TG12.1 – Civil/Sitework at Grade/Ground Level Landscaping

Questions are numbered in the order received. Numbers missing in the sequence either have been answered in a previous response set or will be answered in a future set.

Based on Sheet C1-6001

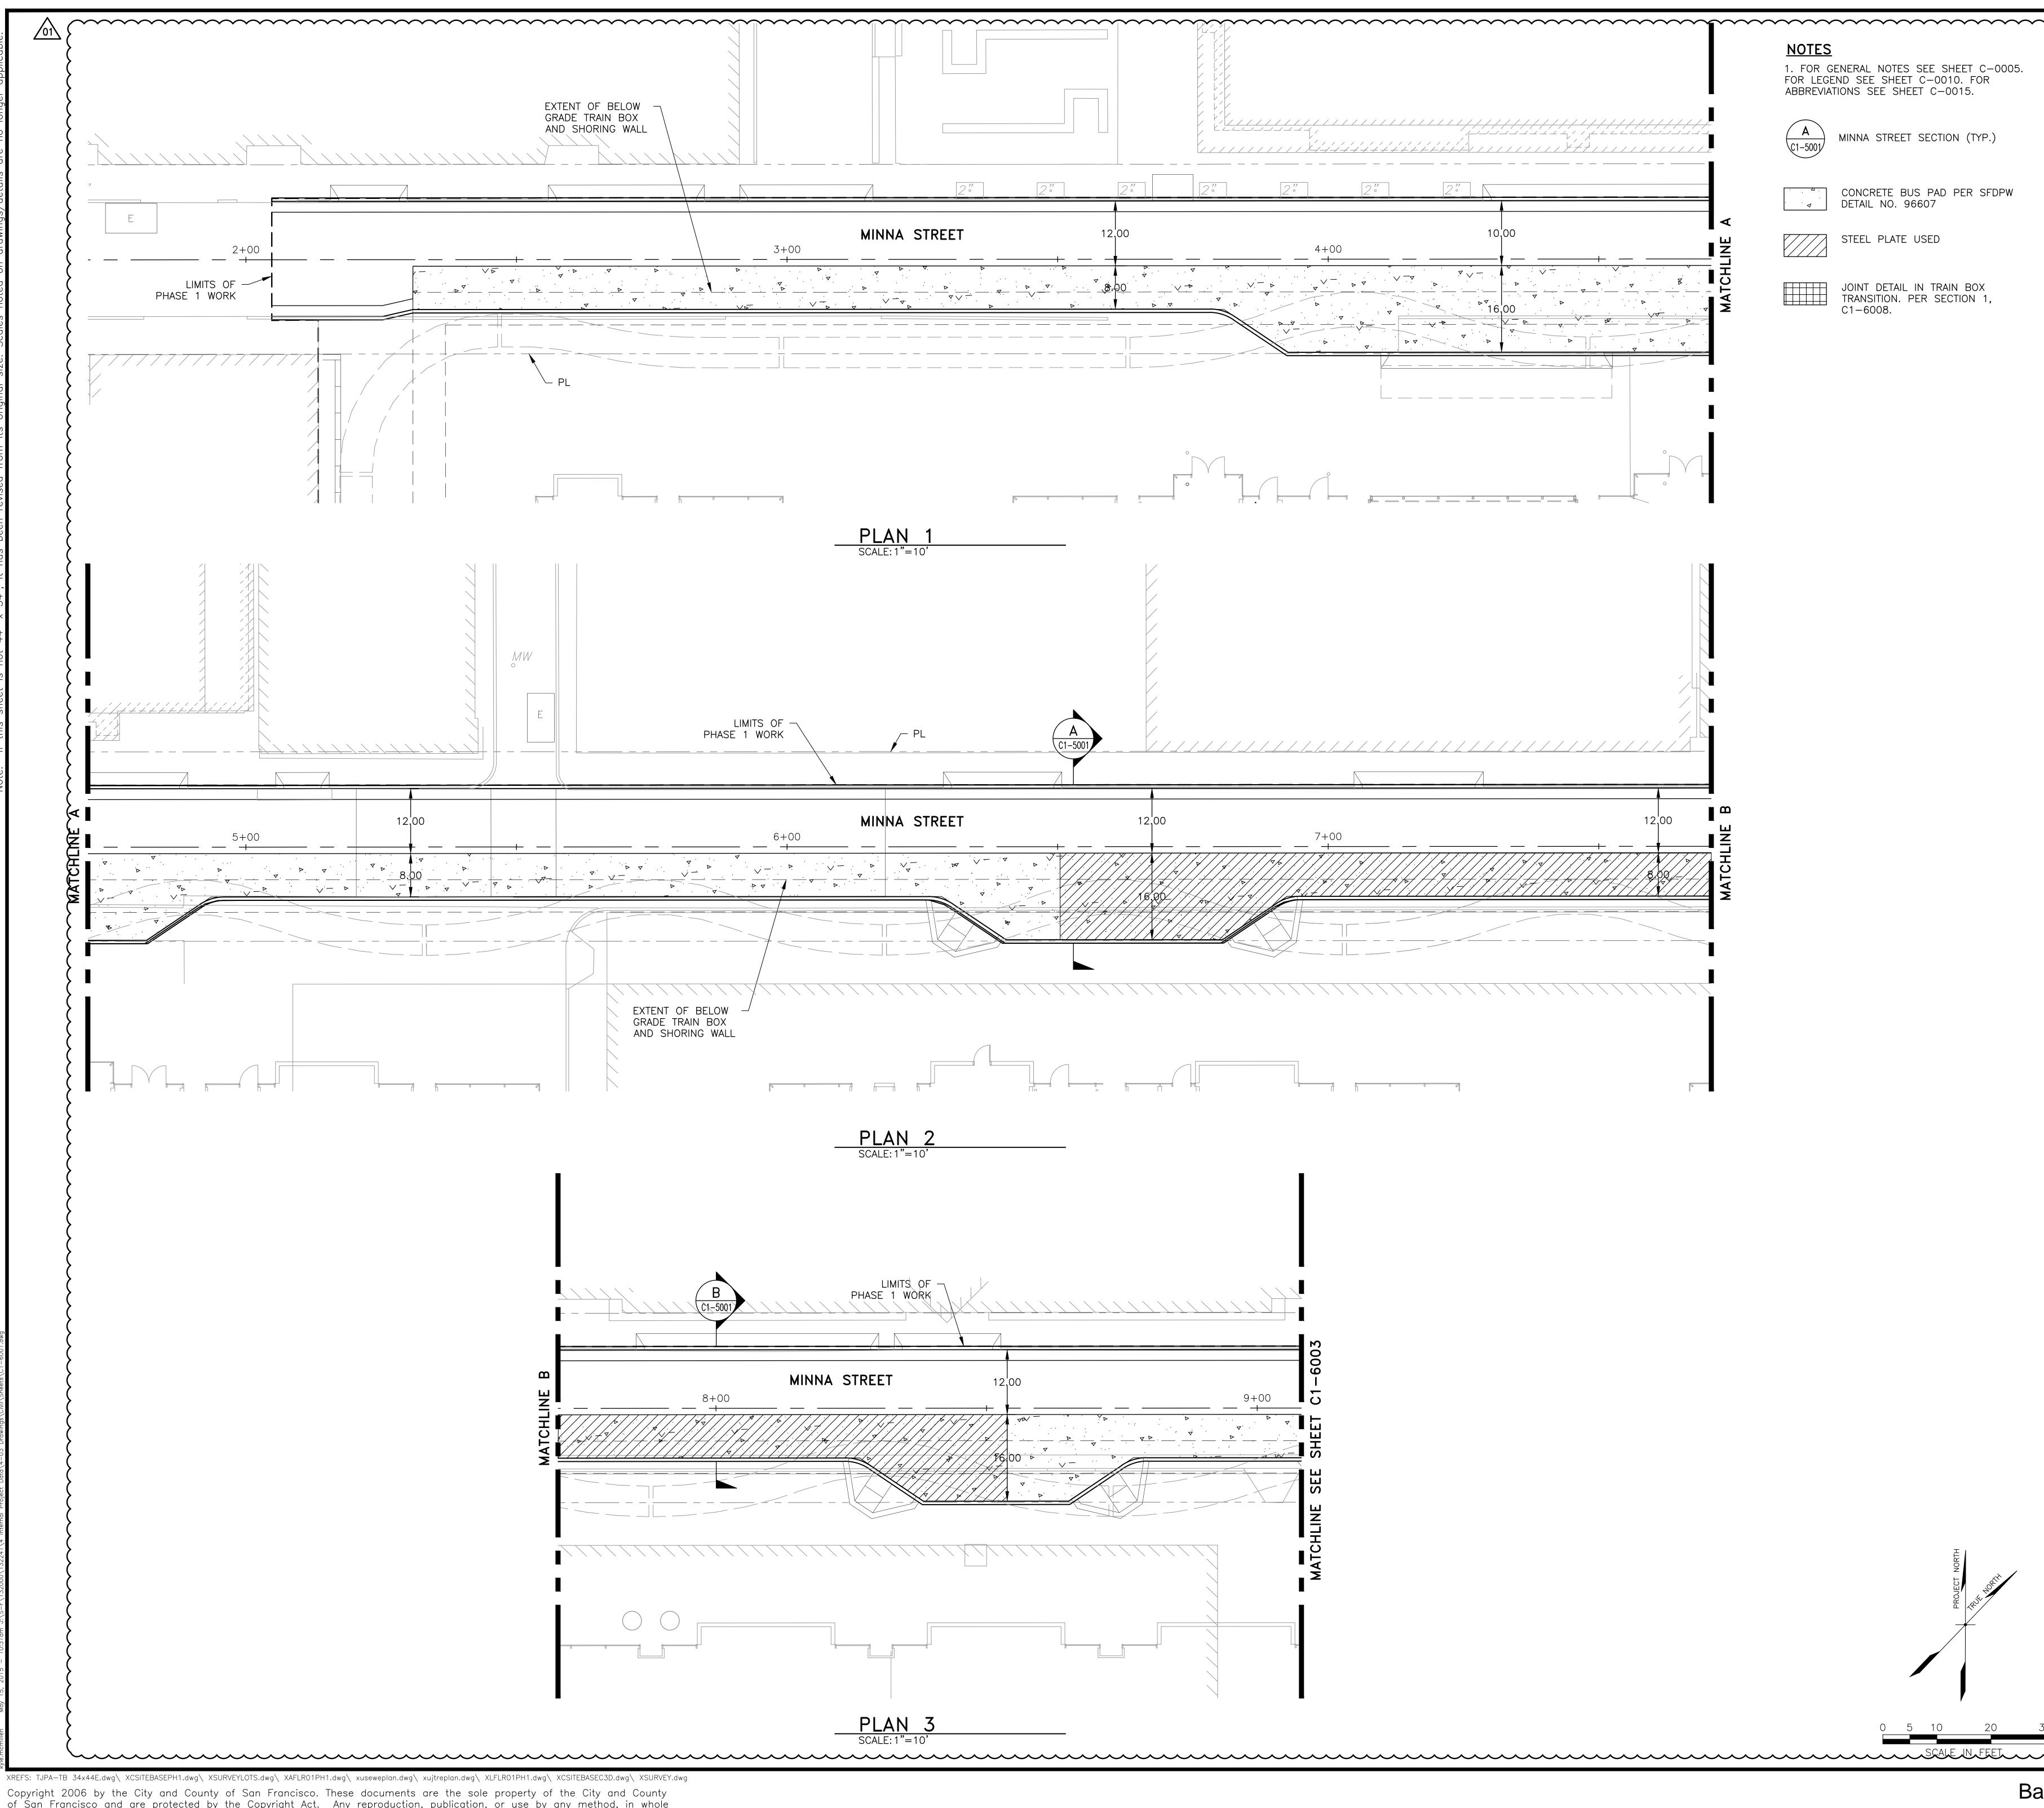
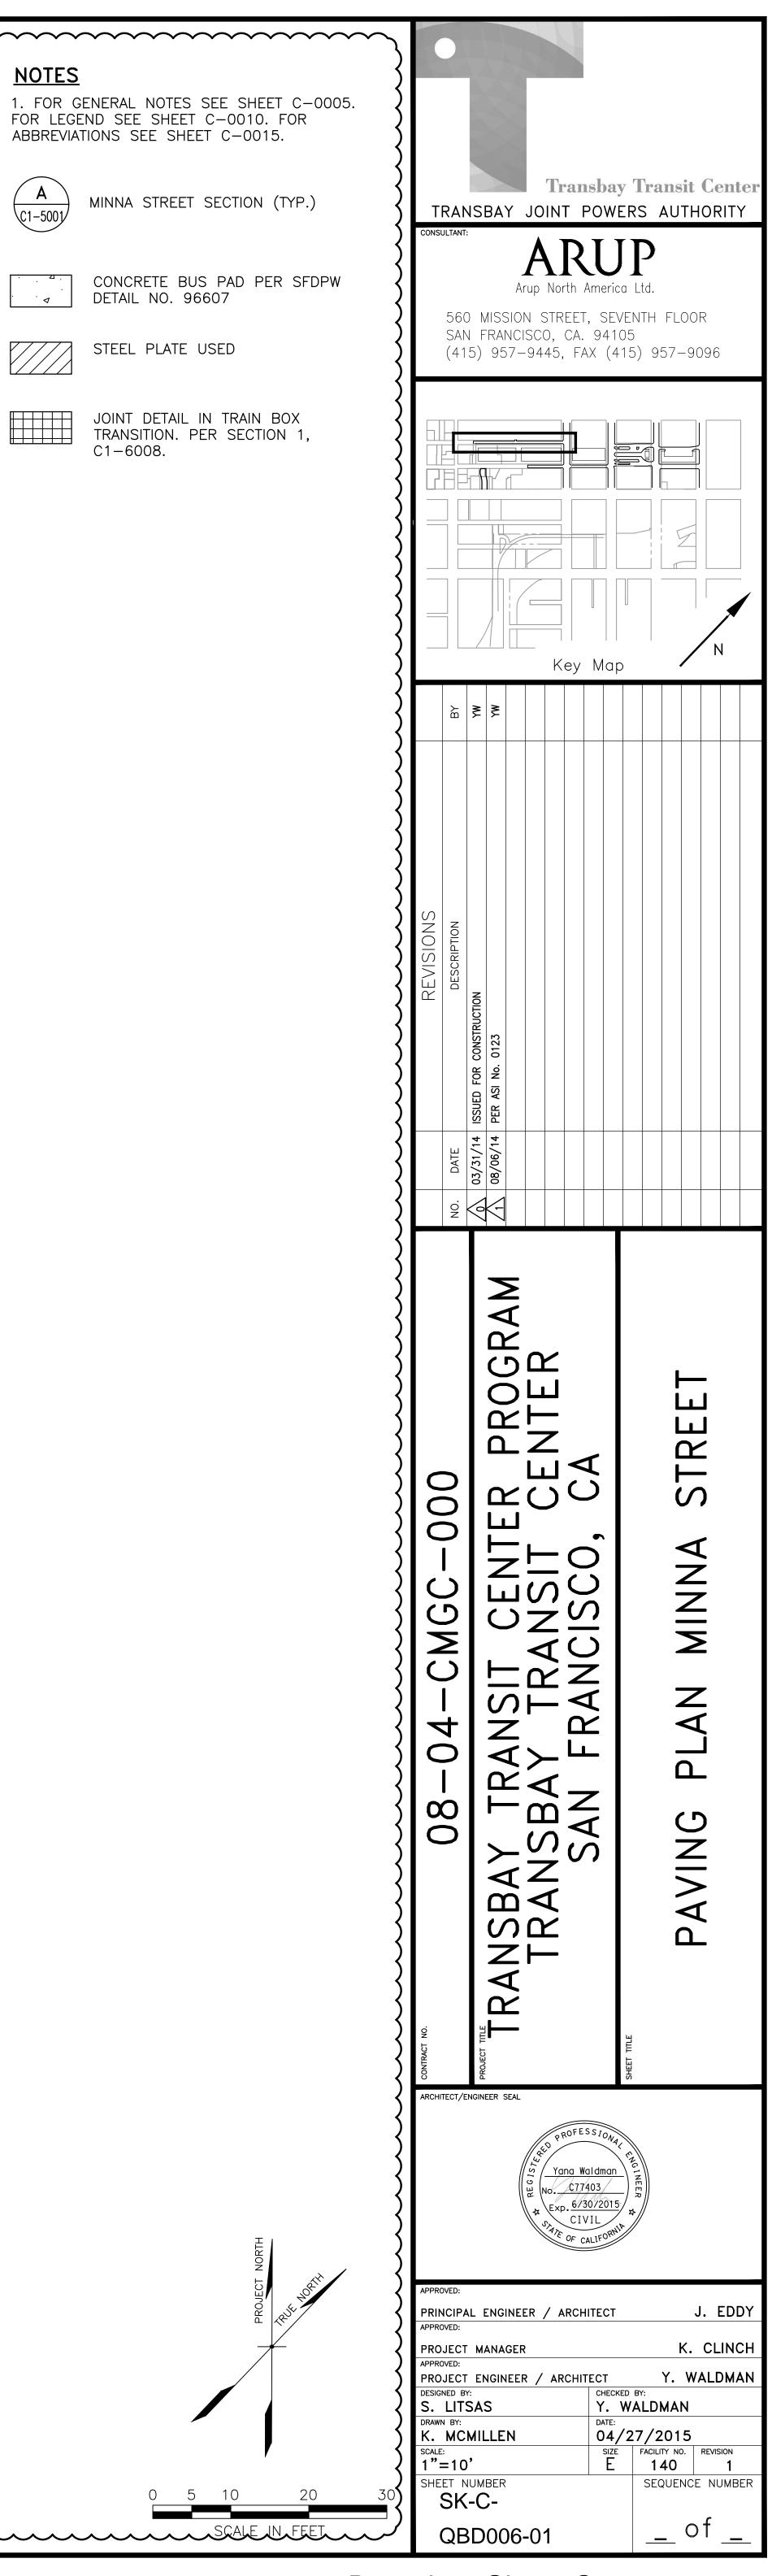
Question No.	Submission Date	Drawing No.	Document/ Spec. No.	Question	Response
TG12.1- 001	5/7/2015	C1- 2000s, C1- 4000s, C1- 5000s		Plan Sheets C1-200x, C1-400x, C1-500x (x = various numbers) graphically show curbs without gutter sections. This is consistent with Note 4 on the various C1-500x sheets, which refers to 6" Curb per SFDPW Std #87169. But the Paving Plans (Sheets C1-600x) graphically indicate that the curb adjacent to the typical street buildup sections (C1-6008) is a curb and gutter section, as depicted on SFDPW Std #87170, rather than curb-only. Please clarify.	Curb and gutter to be provided as shown graphically in the Paving Plans (Sheets C1- 600x). Refer to SFDPW Std #87170 for curb and gutter sections.
TG12.1- 006	5/7/2015	C1-6008 & C1- 5001-C1- 5005		Plan Sheet C1-6008 shows that 1/4" steel plate is to be used in lieu of 6" of sub-base when 6" isn't available. How do we determine where the steel plate will be required? Plan Sheets C1-5001 thru C1-5005 indicate that much of the street area over the box is very close to this 6" minimum, and the cost differential between steel and sub-base is significant.	For clarification of steel protection plate locations, please refer to attached Civil Sketches QBD006-01 through QBD006-05. Steel plate is not part of TG12.1 scope.
